APPENDIX H

CONSULTATION WITH THE NATIONAL CAPITAL PLANNING COMMISSION

Executive Director's Recommendation

PROJECT
New Monumental Arch
George Washington Memorial Parkway
Memorial Avenue
Washington, DC

Monumental Arch: Front Elevation

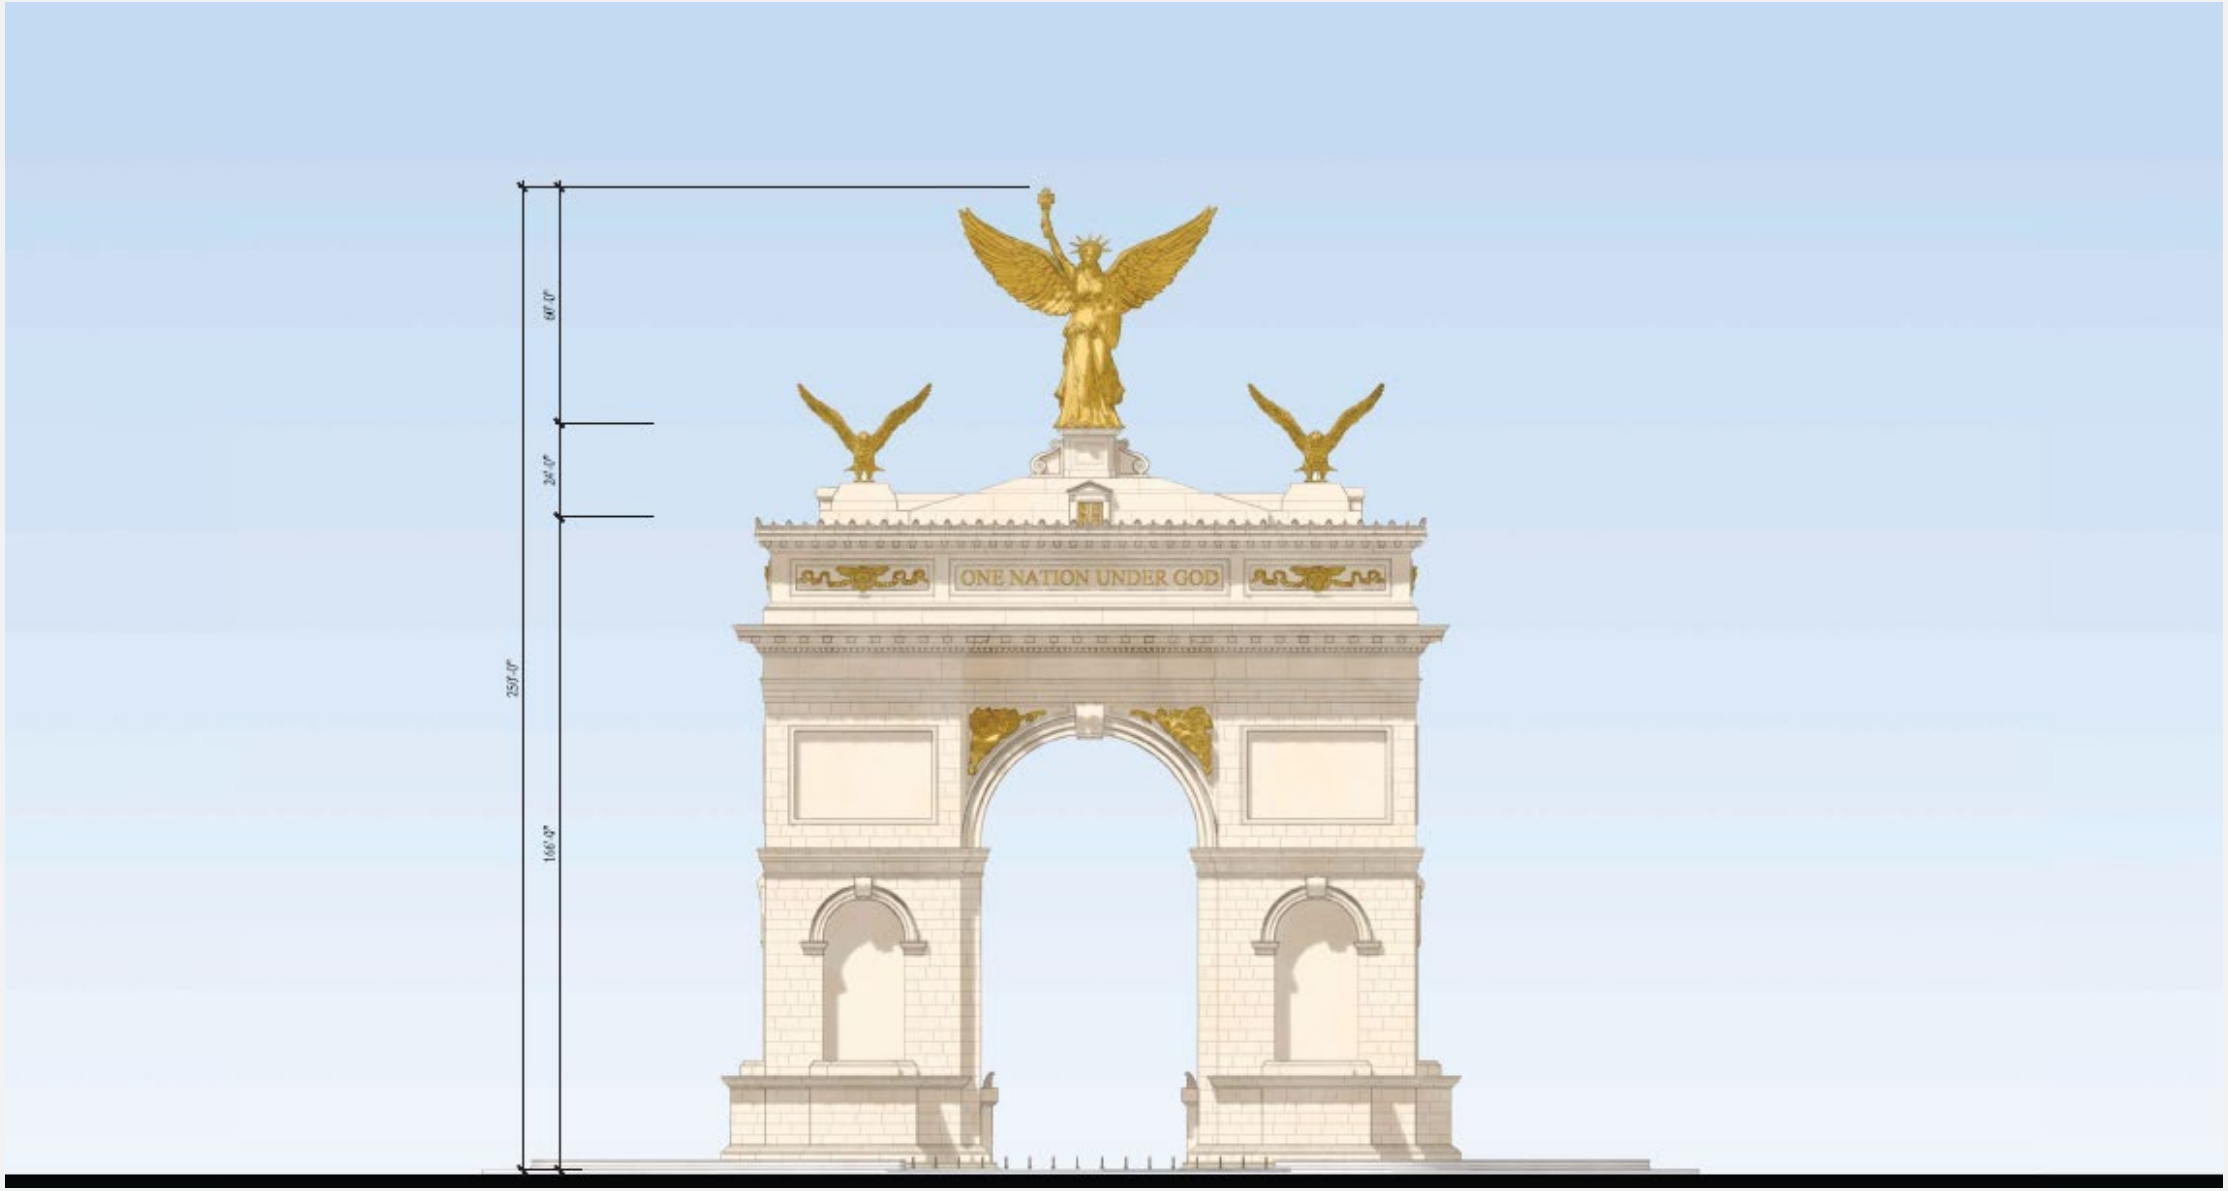
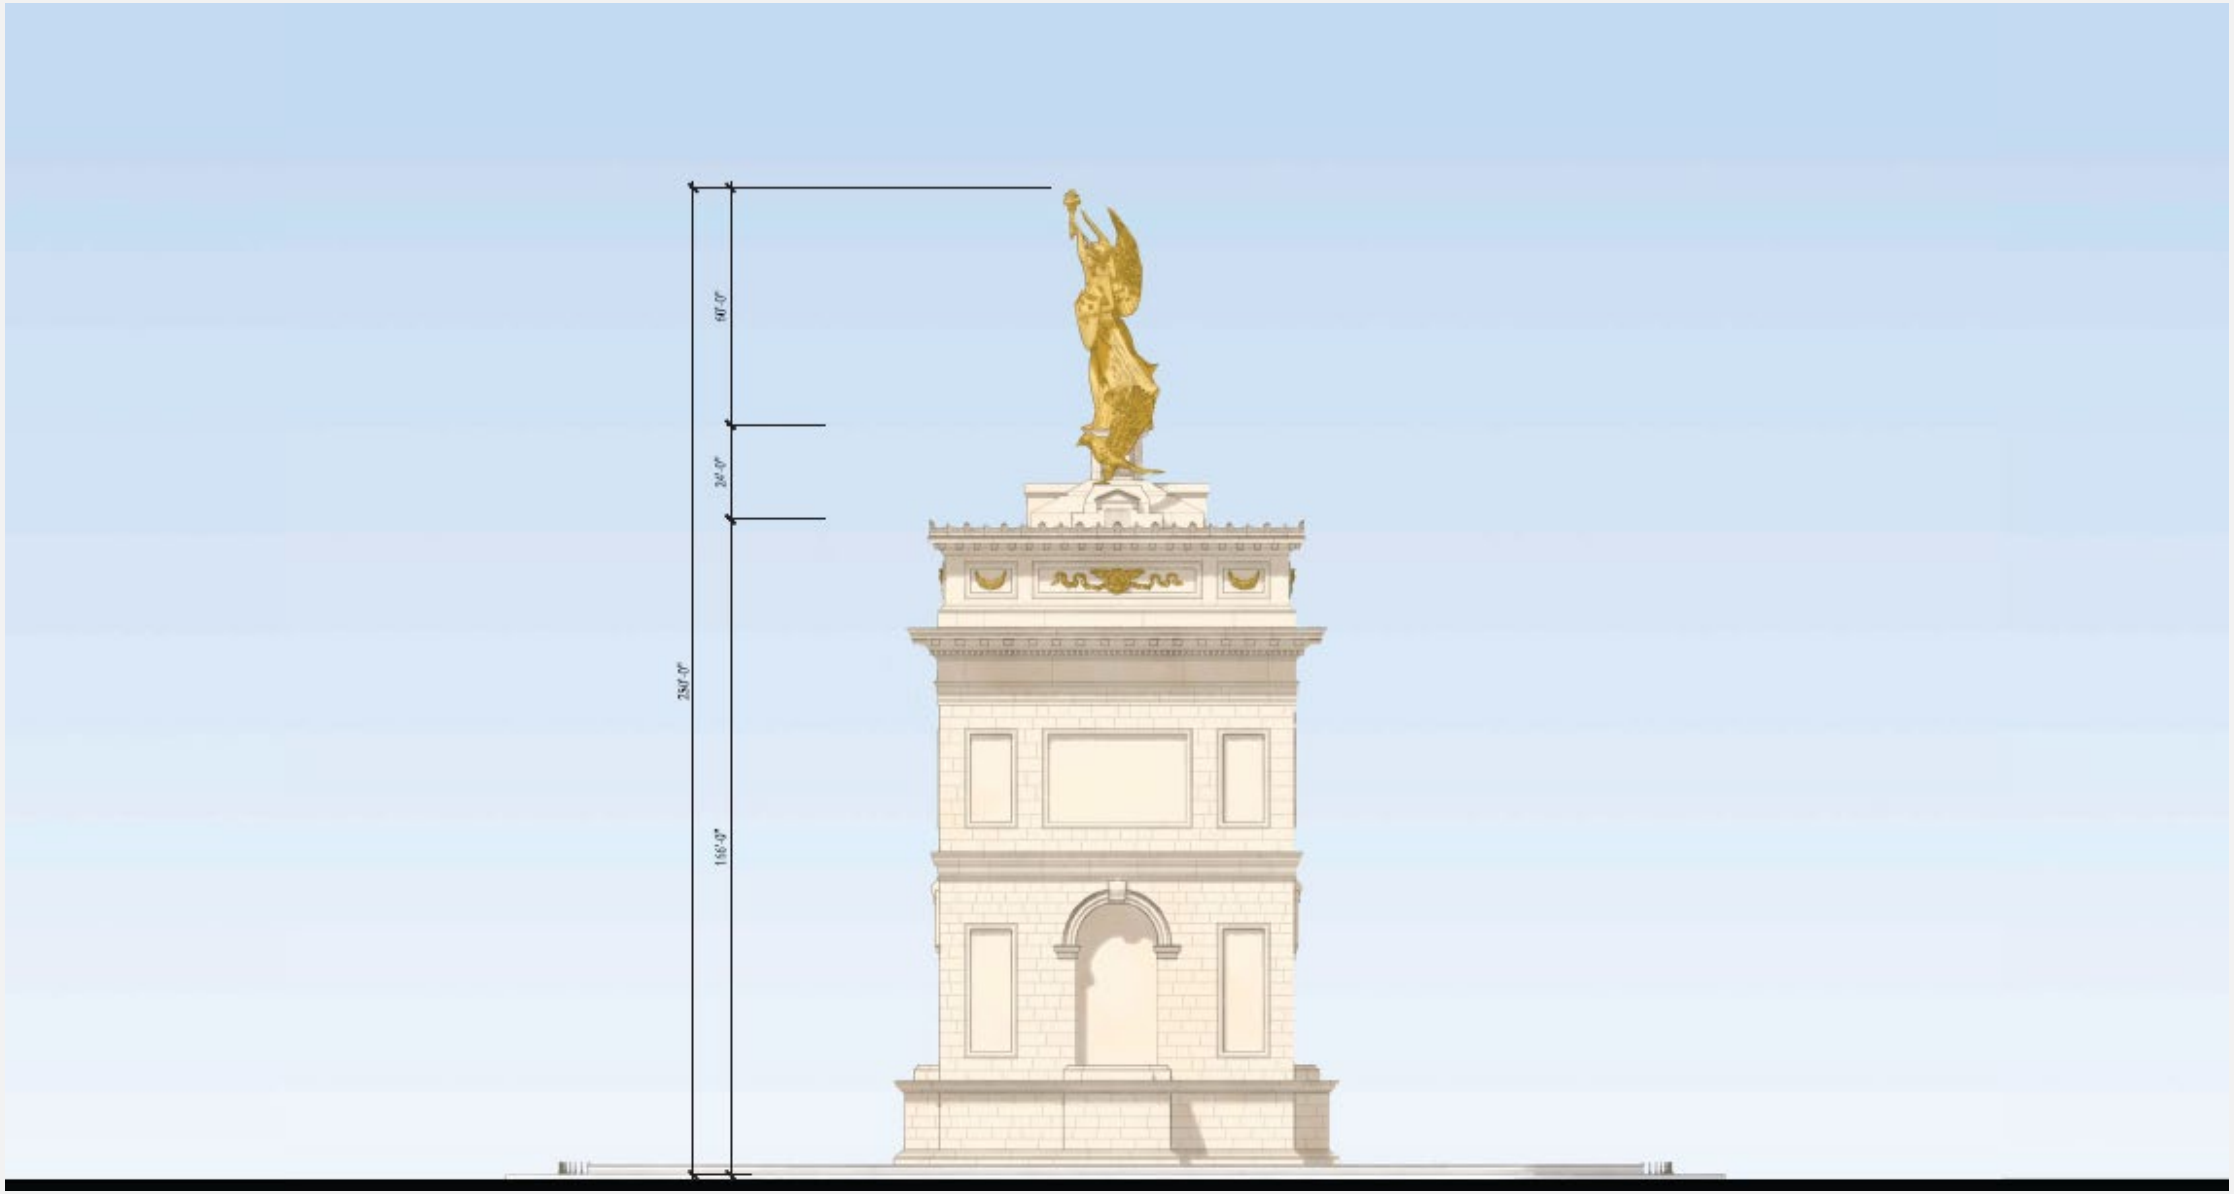
According to the renderings in the submission materials, the proposed arch will block the view of the Lincoln Memorial from Arlington House and alter the view from the Lincoln Memorial to Arlington House. Given the importance of this view, staff suggests the **Commission encourage the applicant provide, as part of the Section 106 process of the National Historic Preservation Act, any design options that were explored to avoid or minimize impacts on the visual connection between Arlington House and the Lincoln Memorial.** In addition, staff suggests the **Commission request the applicant provide, as part of the next review, updated photo-visualizations (renderings) of existing and proposed pedestrian-level views from the additional locations noted below:**

Final Design

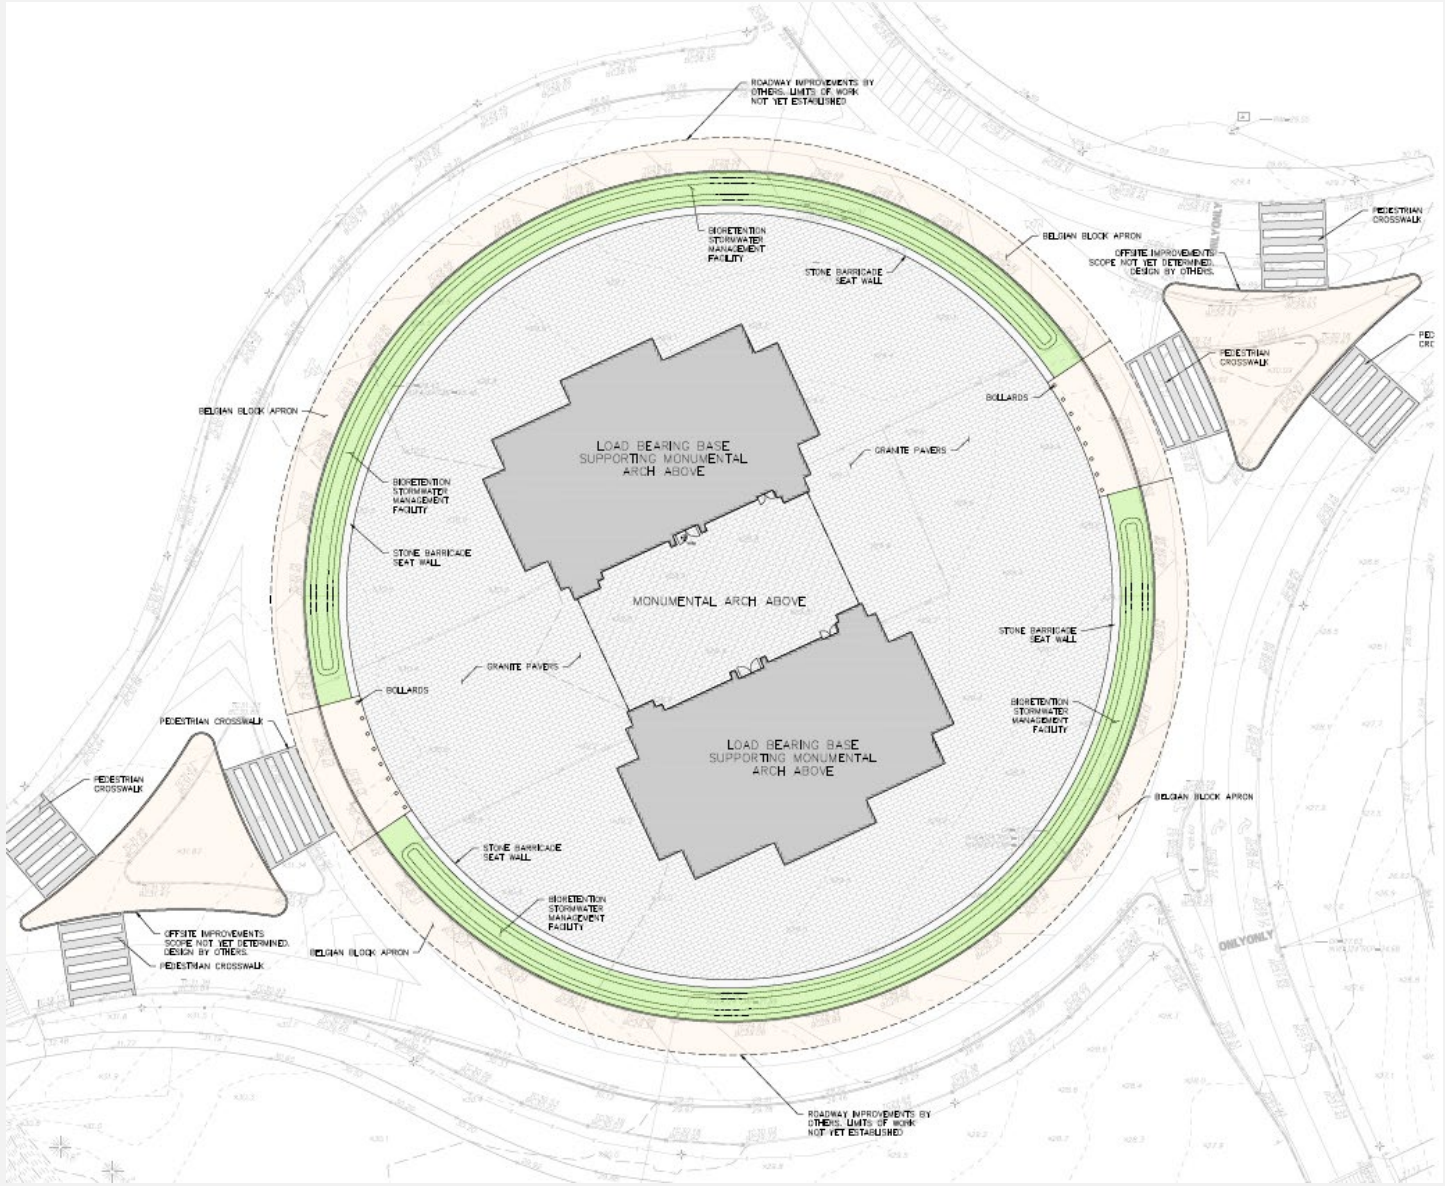
Updates:

- 15 Traffic Signals removed, 2 minimum maintained at each pedestrian crossing

Future Queue Length - Washington Boulevard

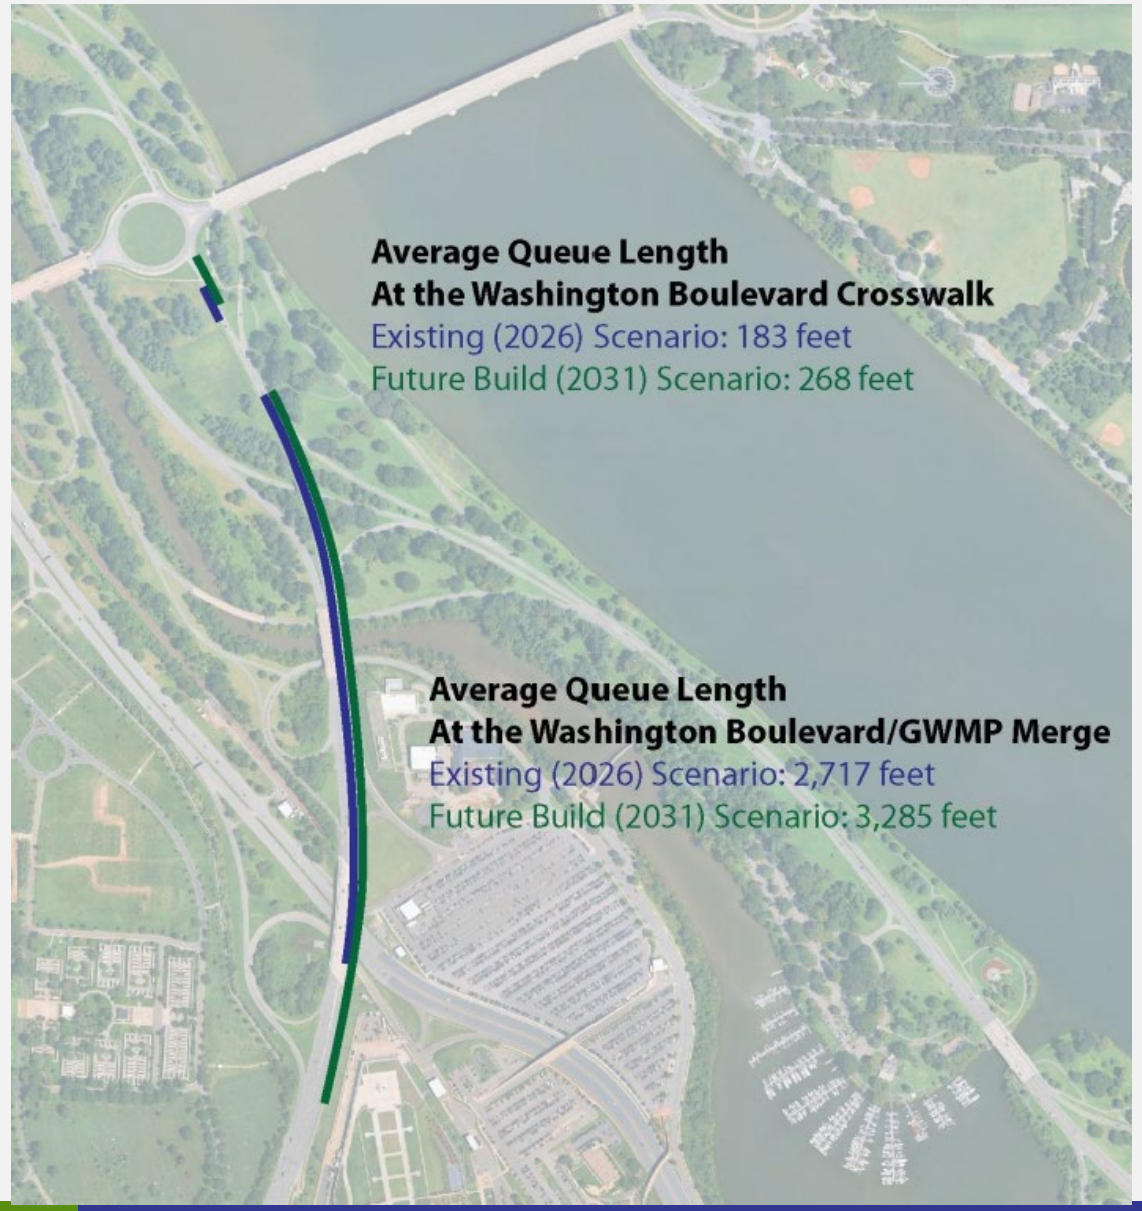
The traffic operations analysis demonstrates that during the weekday morning commuter peak period congestion originates along Washington Boulevard at the merge point with the GWMP ramp, south of AMC. The weave condition leads to an average queue length of about 2,700 feet today and is expected to maintain a length of about 3,000 feet in the future. This average queue length does not extend to the interchange with I-395, which is approximately 7,000 feet south of AMC.

Final Lighting Plan

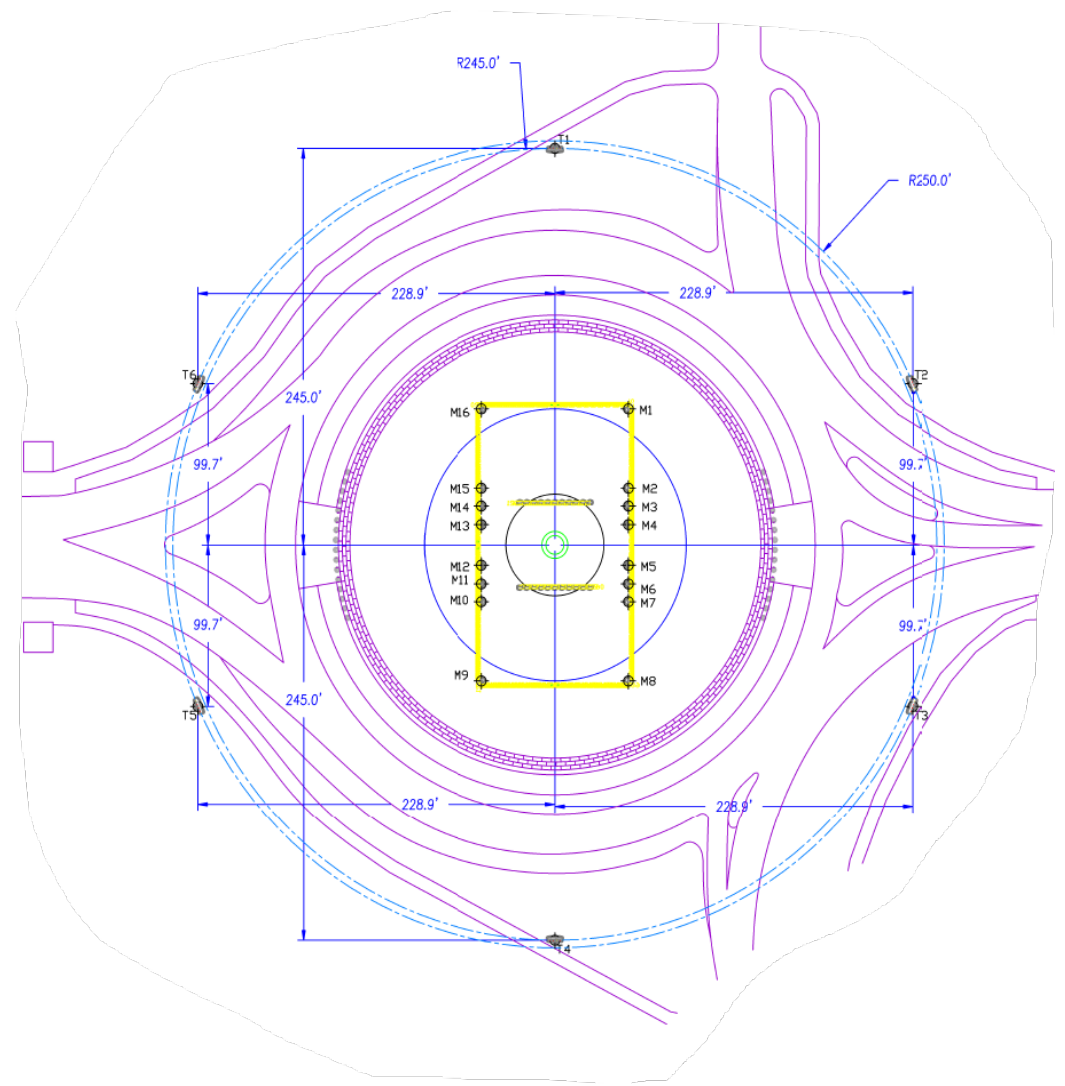
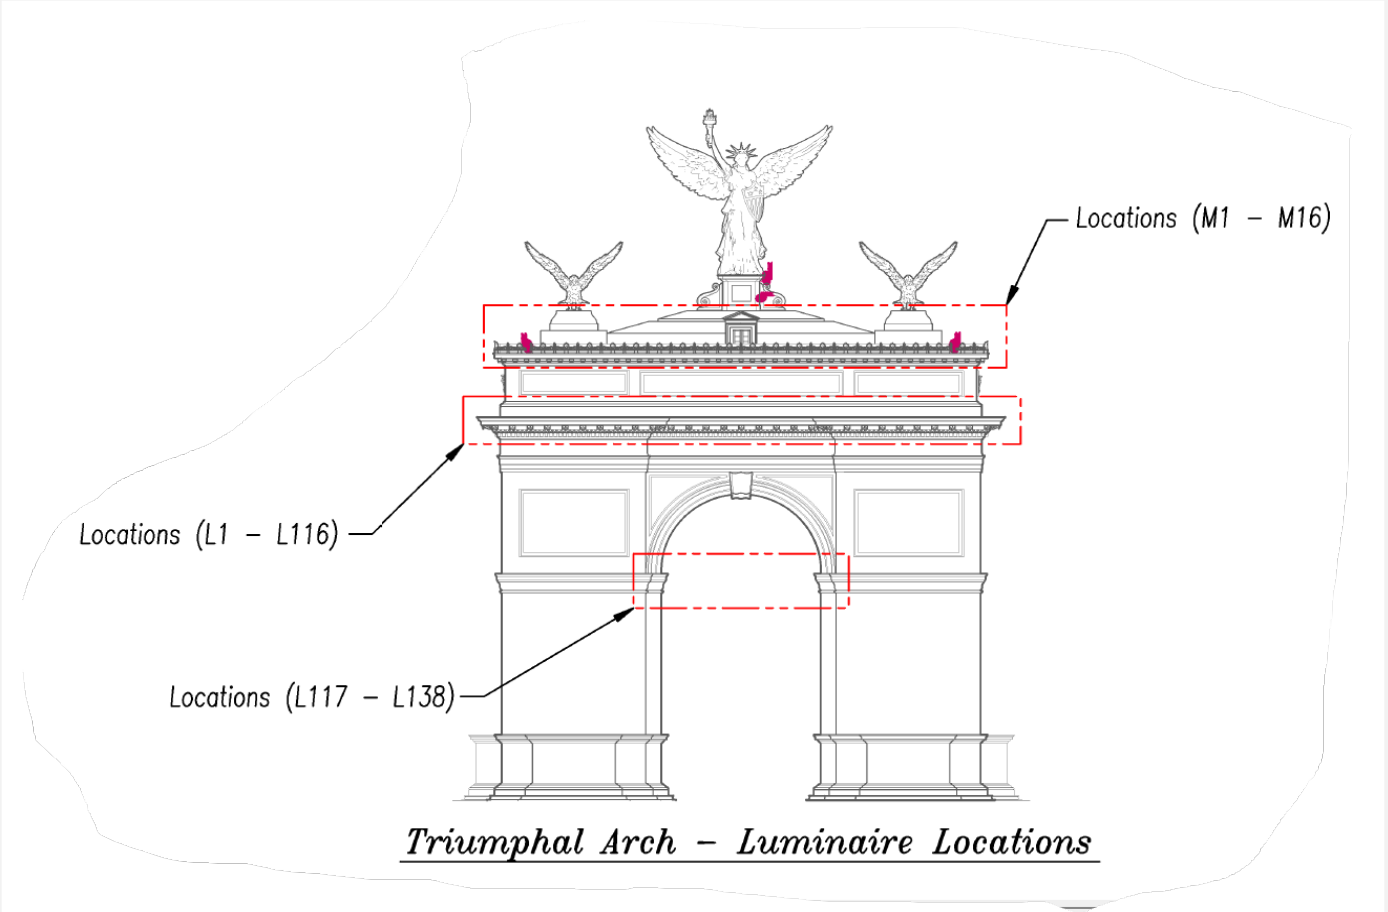
Notes the Federal Aviation Administration provided the applicant with a *Determination of no hazard to air navigation* finding for the proposed arch with a condition for safety lighting that includes a non-standard eternal flame and continuous floodlighting by searchlight projectors installed at three or more equidistant points to provide illumination to the top one-third of the structure which are included in the final submission.

On September 18, 2026 the FAA provided NPS with a “DETERMINATION OF NO HAZARD TO AIR NAVIGATION” finding for the Triumphal Arch. Section 7, provides the following condition for safety lighting; “*The proposed structure should be appropriately marked/lighted with a non-standard eternal flame and continuously floodlighted by searchlight projectors installed at three or more equidistant points around the base of the structure. The searchlight projectors should provide an average illumination of at least 15 foot-candles (161.46 lux) over the top one-third of the structure, in accordance with FAA AC 70/7460-1N, Paragraph 4.5, to make it more conspicuous to airmen.*”
